Drawing Change Notice

CHANGE DOCUMENT NO.
24590-PTF-VDCN-MS-11-00007

JOB NO.	TITLE FOR CHANGE NOTICE
24590	PTF-FRP-VSL-00002D REDESIGN

JUSTIFICATION FOR CHANGE	CAUSE CODE
Based on the re-analysis of FRP-VSL-00002A/B/C/D, per calculation 24590-PTF-MVC-FRP-00003, for revised seismic conditions and design evolution, a redesign of the vessel is required.	01-23

24590-QL-SRA-MTF5-00001-20-24 REV 00D

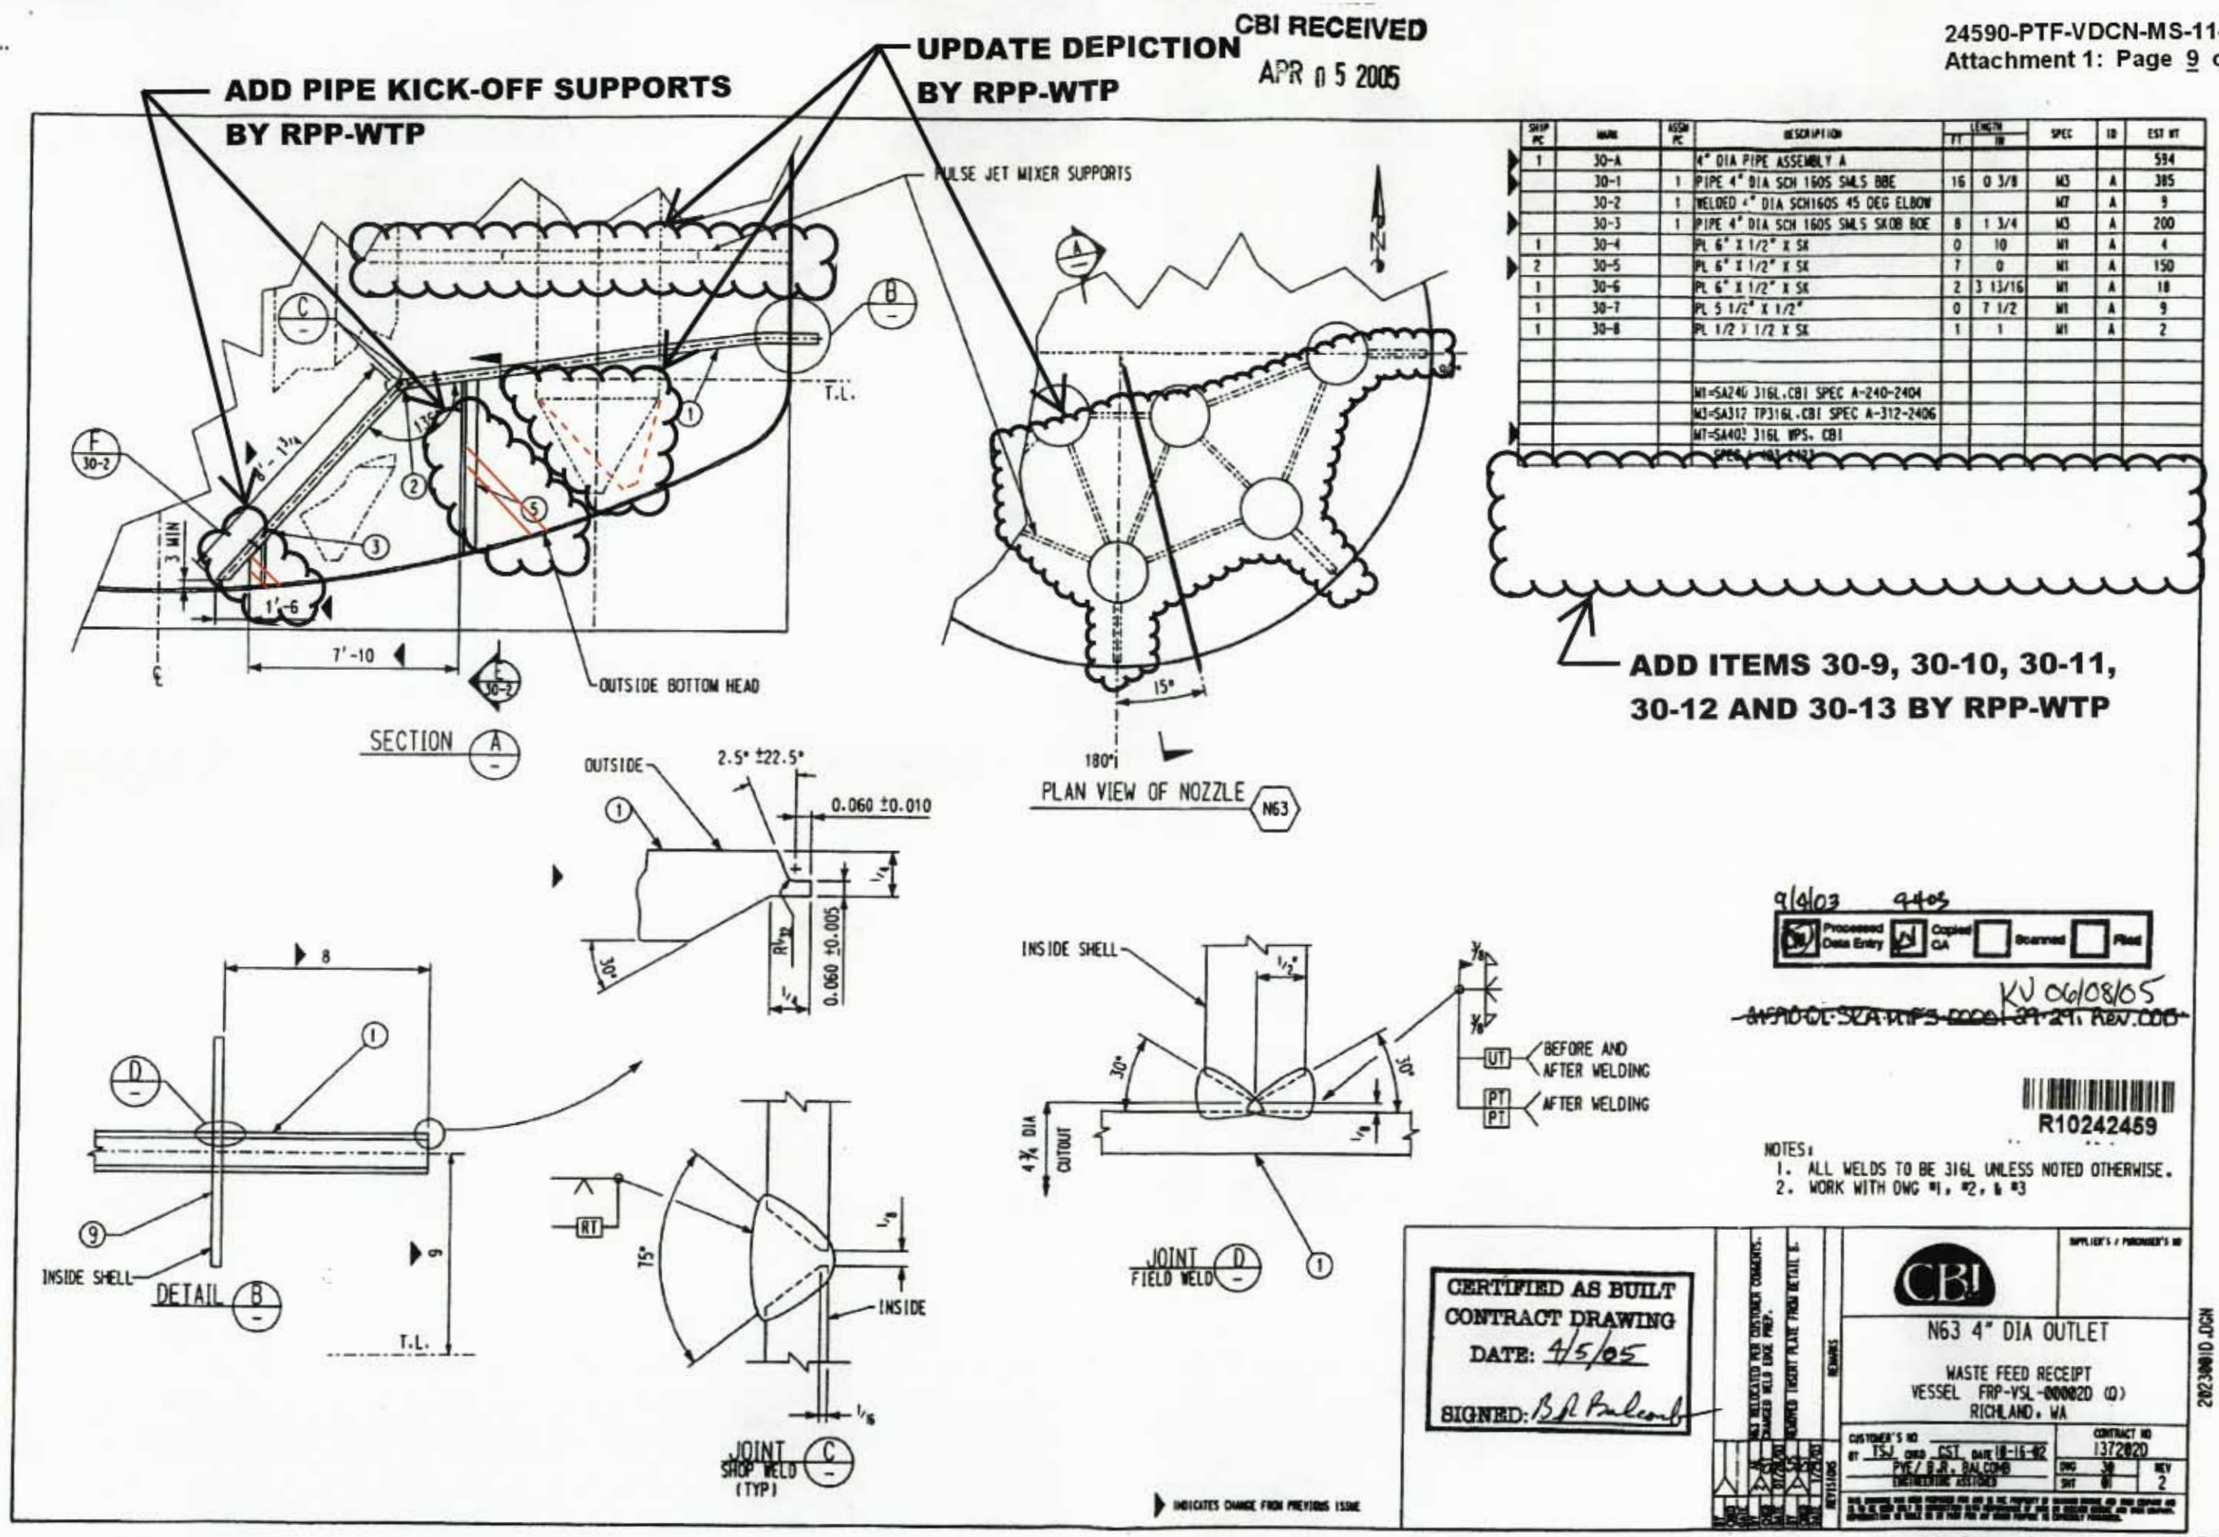
8. Affected Document: 24590-QL-SRA-MTF5-00001-29-24 (see Attachment 1, page 8 of this VDCN).

a) Drawing: Delete the following:

Items 5, 6, 12, 13, 14, 15, 16 and 17

Section X-X

24590-QL-SRA-MTF5-00001- 29-30
REV 00D

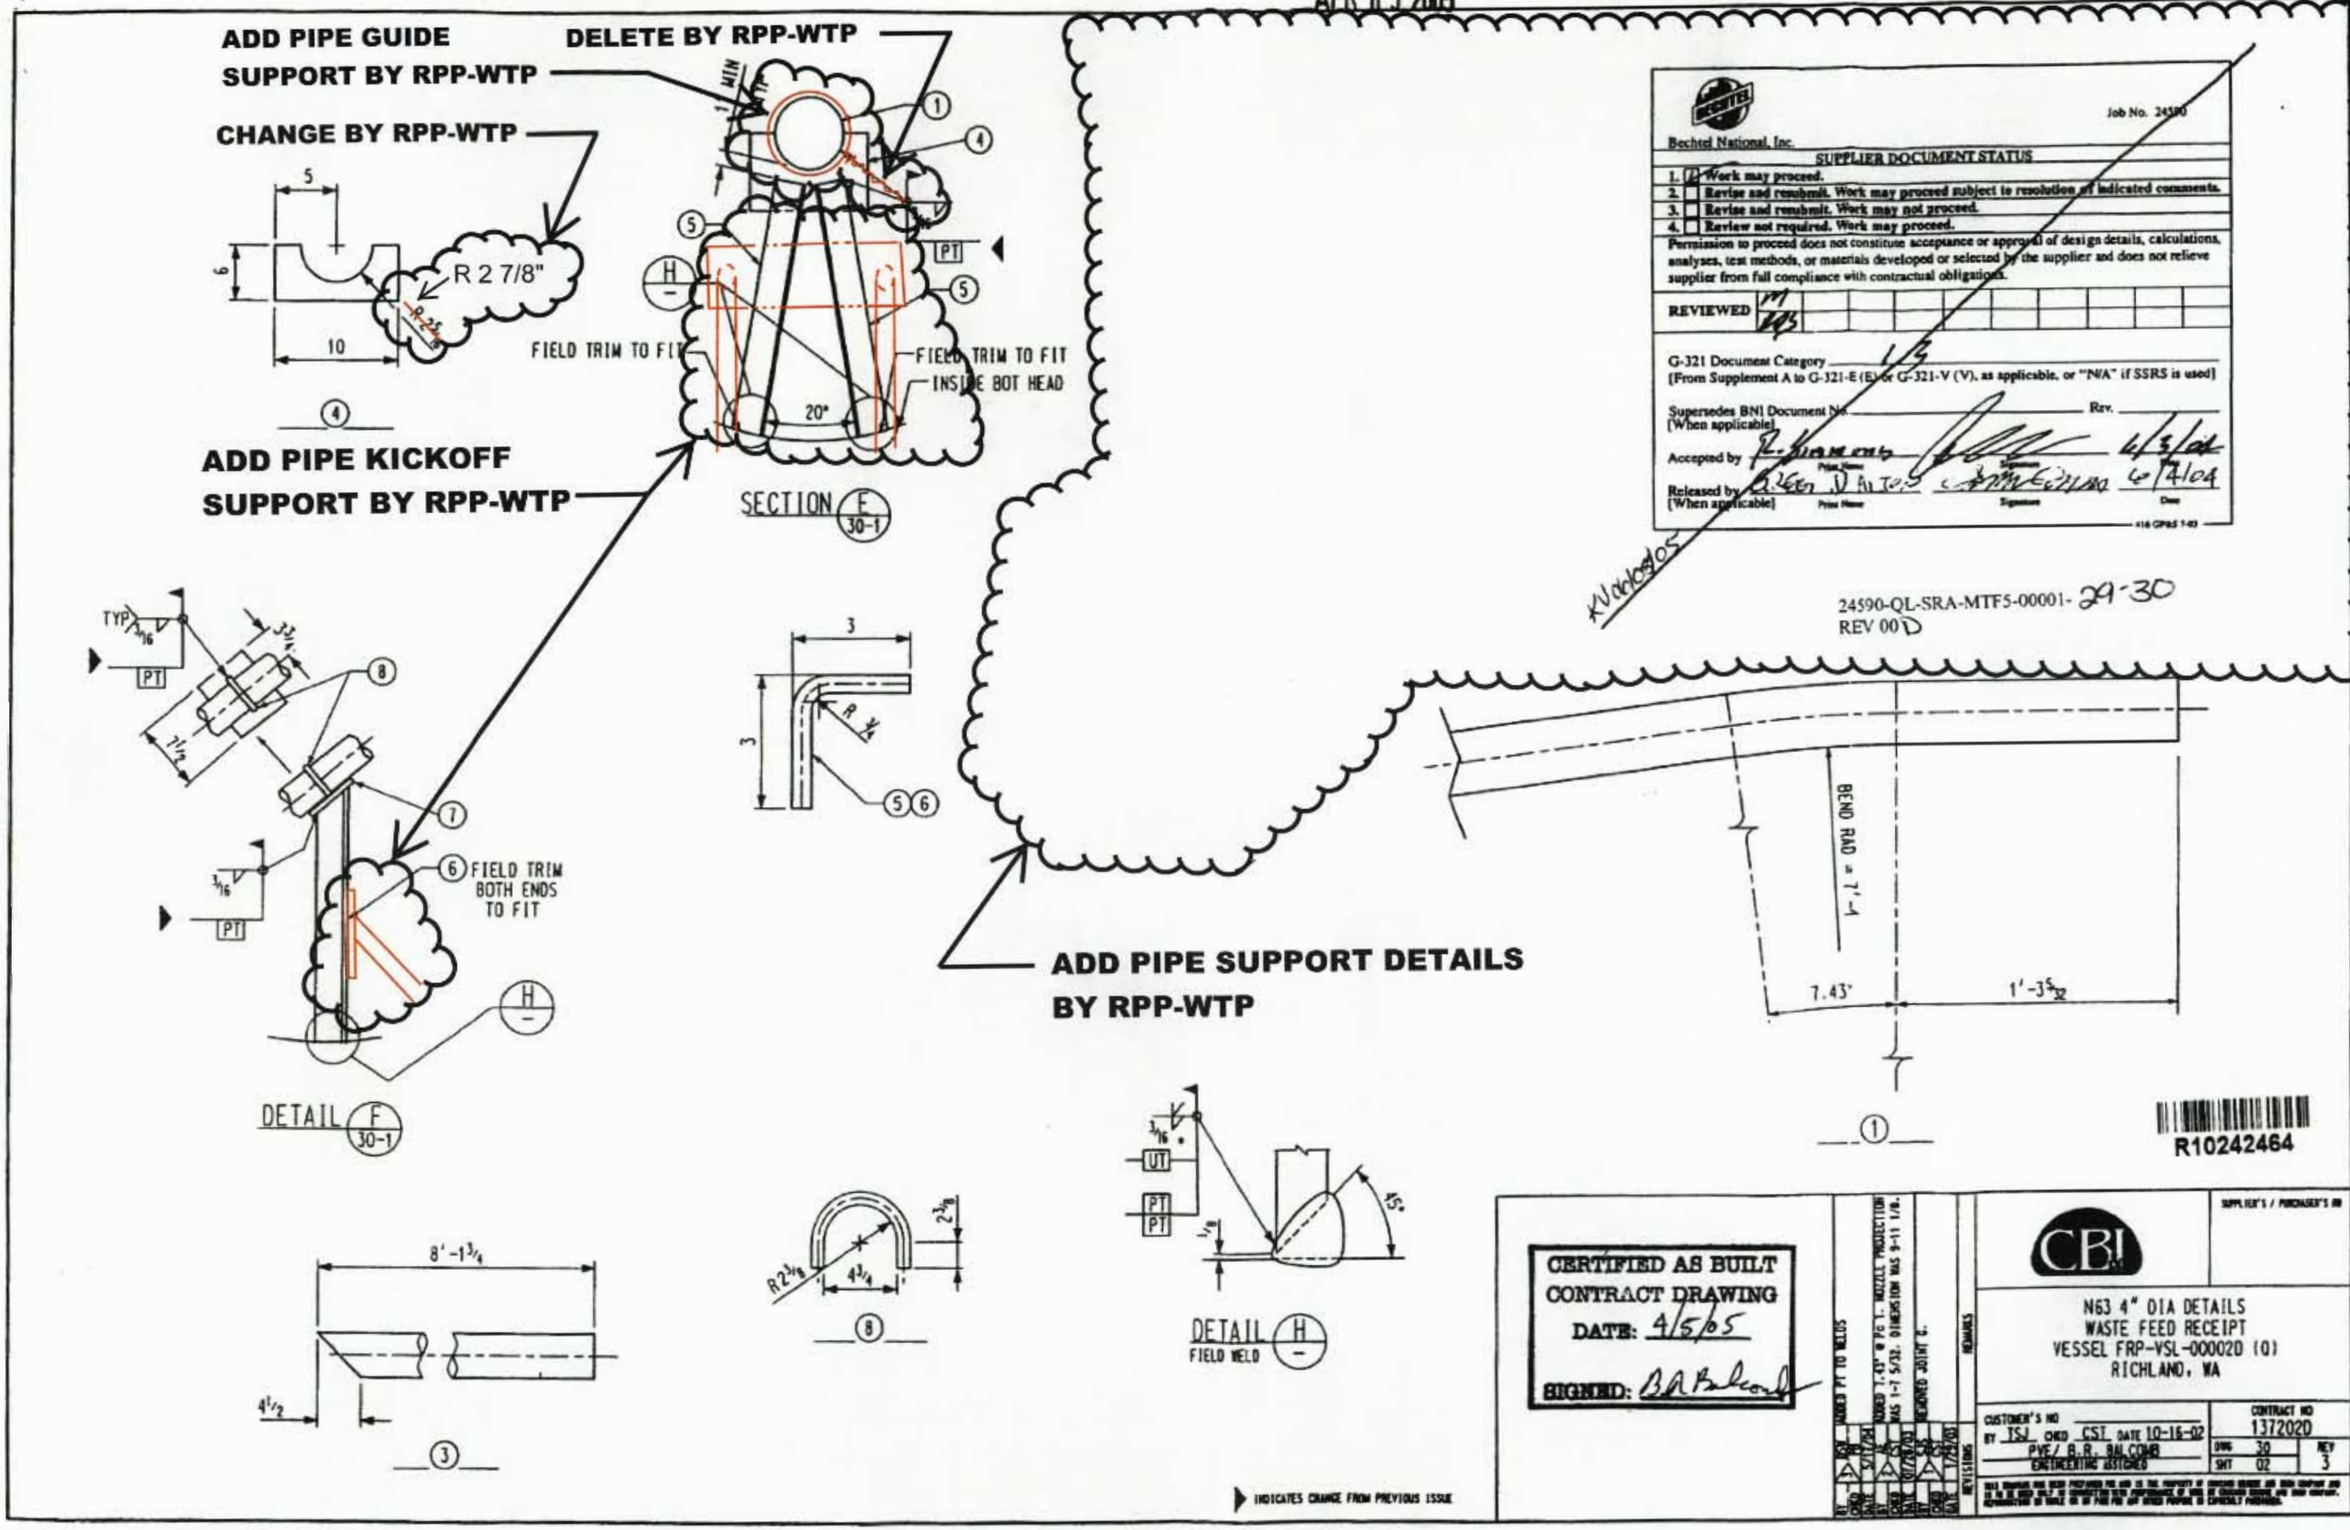
10. Affected Document: 24590-QL-SRA-MTF5-00001-29-30 (see Attachment 1, page 10 of this VDCN).

a) Section E: Add the following Items shown on Attachment 1, page 15 of this VDCN.

b) Detail F: Add the following Items shown on Attachment 1, page 15 of this VDCN.

c) N63 4" Dia Details Drawing: Add the following Sections, View and Items shown on Attachment 1, page 15 of this VDCN.

24590-QL-SKA-XTCS-00001-29-00073-K

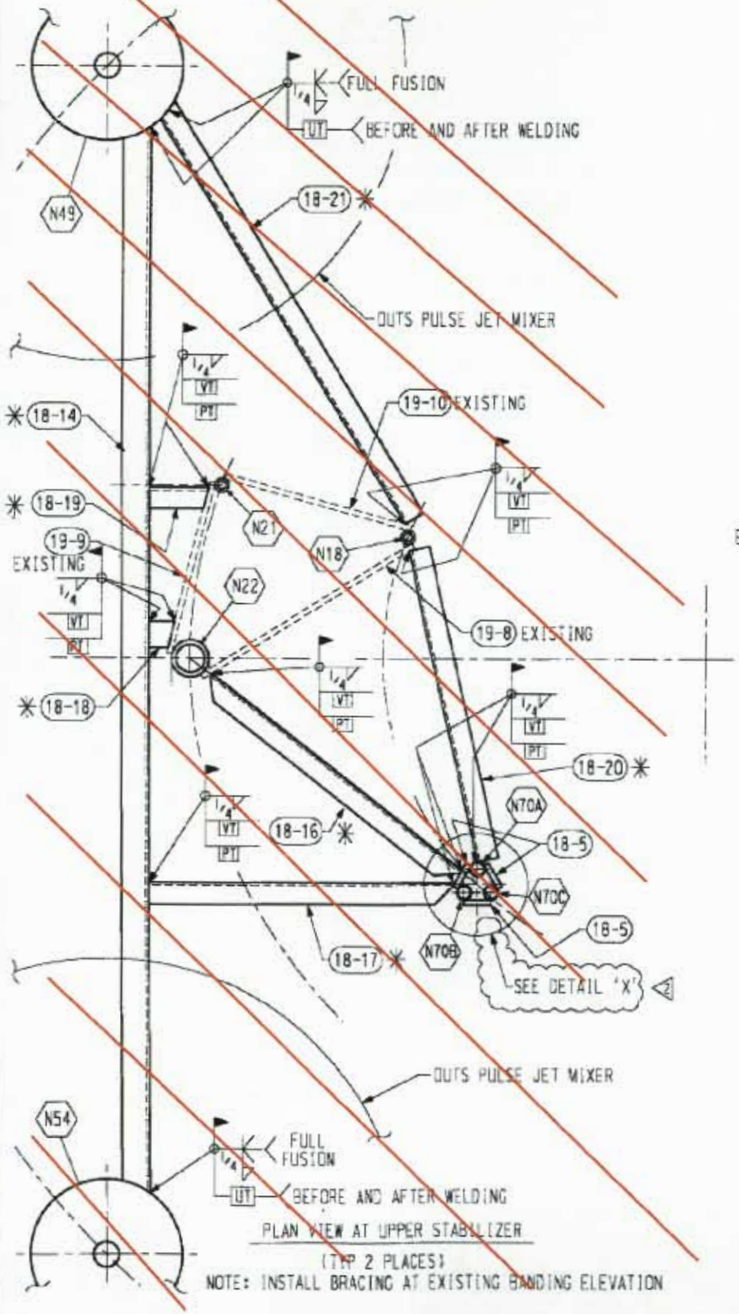
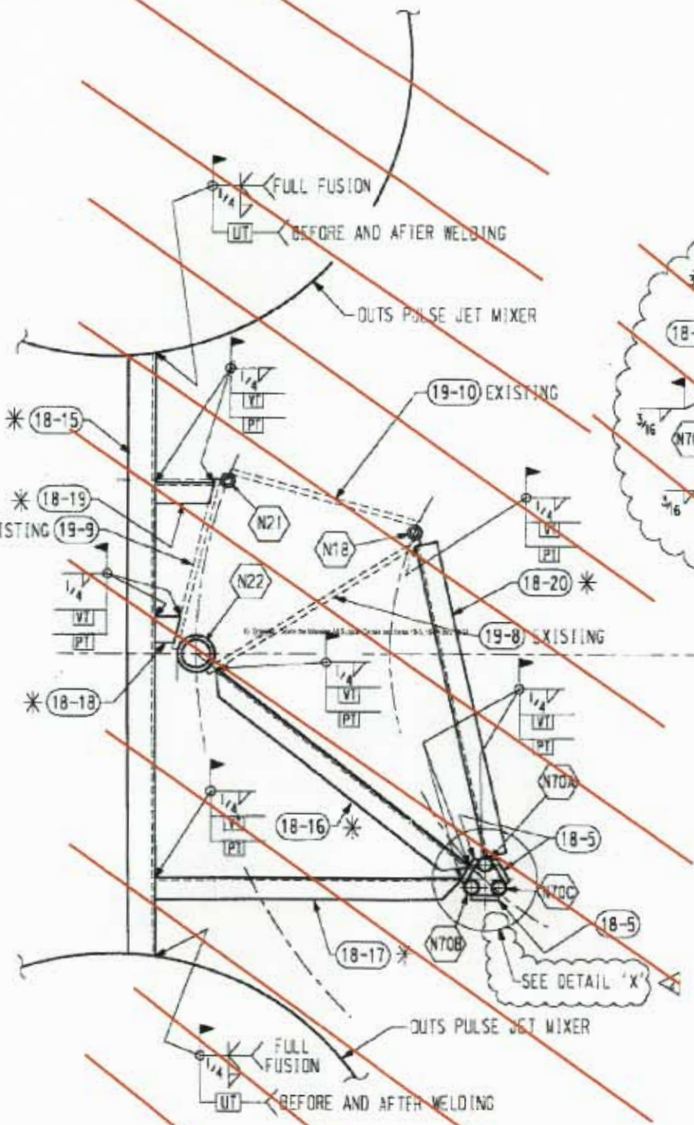
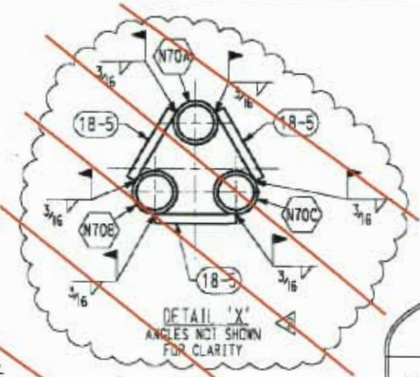
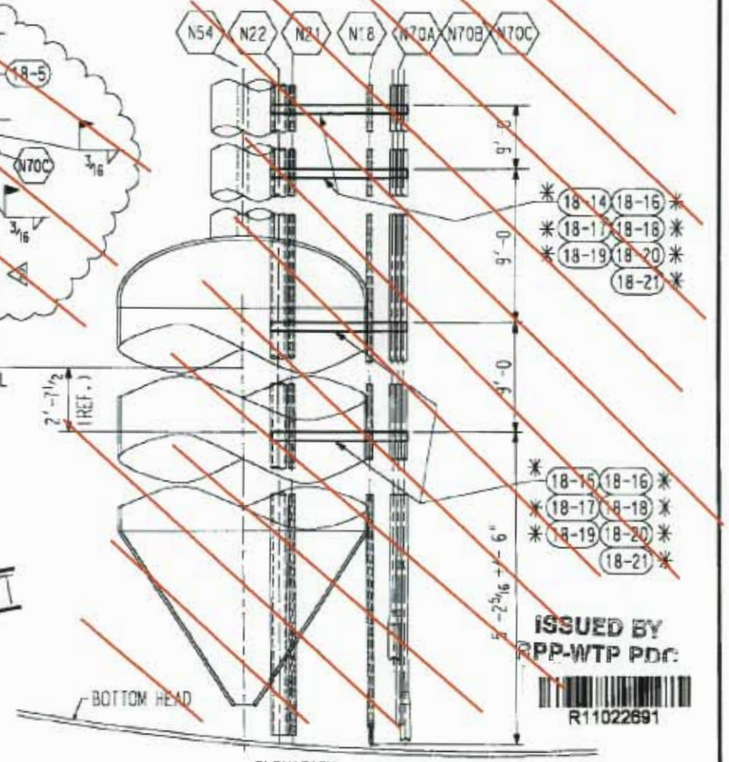
11. Affected Document: 24590-QL-SRA-MTF5-00001-29-73 (see Attachment 1, page 11 of this VDCN).

a) Bill of Materials block: Delete the following line Items:

b) Drawing: Delete the following All Support Details and Items 18-5, 18-14 thru 18-21.

DELETE AND REPLACE WITH DIP
PIPE SUPPORT DETAILS BY RPP-WTP
IN CROSS HATCH AREA
